Brook Mining Co., LLC - Coal Mining Permit Application 2nd Notice

RE: Renewed Request for an Informal Conference regarding Big Horn Coal Company's Written Objections to Brook Mining Co., LLC's Coal Mining Permit Application, DEQ File No. TFN 6 2-025

**RE: Objections to Proposed Brook Mine Permit Application, Sheridan County,
Wyoming**

BHCC Objection No. 4 Attachment 1

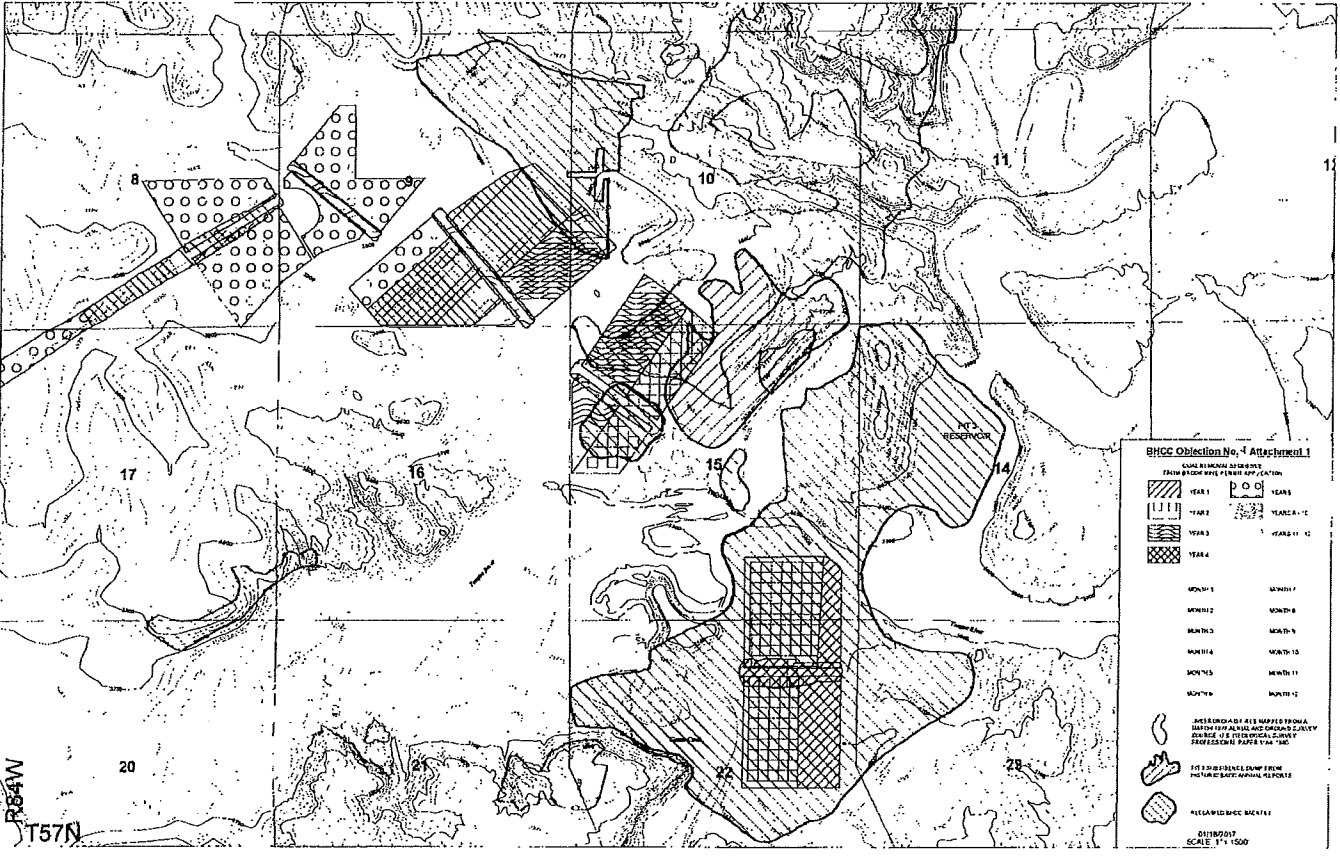
Attachment 1 provided with this Objection No. 4 is a drawing showing the approximate extent of underground coal mine fires in the area of proposed highwall mining in Sections 10 and 15, T57N, R84W, as reported by the U.S. Geological Survey in 1980. The fires in this particular area originated with mining of the Monarch coal. This and other nearby historic underground mines have long been known to exhibit numerous subsidence features and underground coal mine fires, and in the late 1980s BHCC received approval from the WDEQ/LQD to permanently place nearly 10 million bank cubic yards of overburden over the area shown on Attachment 1 in an attempt to reclaim the subsidence and control the fire. That unique reclamation feature is known as the Pit 3 Subsidence Dump in Big Horn Mine's reclamation history. The proposed highwall mining will develop mine openings in the Carney and Masters coal seams beneath the Monarch seam in areas that are known to still exhibit evidence of underground coal fires. Plumes of steam and smoke have been observed again over the general area of Sections 10 and 15 this winter of 2016-2017. These observations indicate that, in places, the perimeter of the historic subsurface coal seam fires has expanded notable distances from the referenced 1980 boundary delineation.

The subsidence control plan of Addendum MP-6 does little to guarantee the long-term protection of BHCC's surface estate especially where highwall mining panels will be driven beneath underground coal mine fires having a long history of activity. Section MP-6.2 of Addendum MP-6 provides numerical calculations for subsidence chimney heights, but there is no investigation of the potential that the historic mine fires may have compromised the structural integrity of strata underlying the fires and overlying the coals targeted for highwall panel mining (the interburden), leaving the interburden more prone to subside than normal. BHCC is particularly concerned and objects to highwall mining beneath or adjacent to pre-existing underground mine fires because of the potential for oxygen and water to be transmitted from the highwall mining openings to "hotspots" in the seams already burning via highwall trenches or via fractured or subsided interburden above the panel openings. BHCC strongly disagrees with the legitimacy of the plan stated in Section MP-6.4 of Addendum MP-6 which states "Backfilling will also be performed if it is determined that the introduction of water and oxygen could contribute to spontaneous ignition of the remaining coal not extracted from the highwall mining operations". BHCC
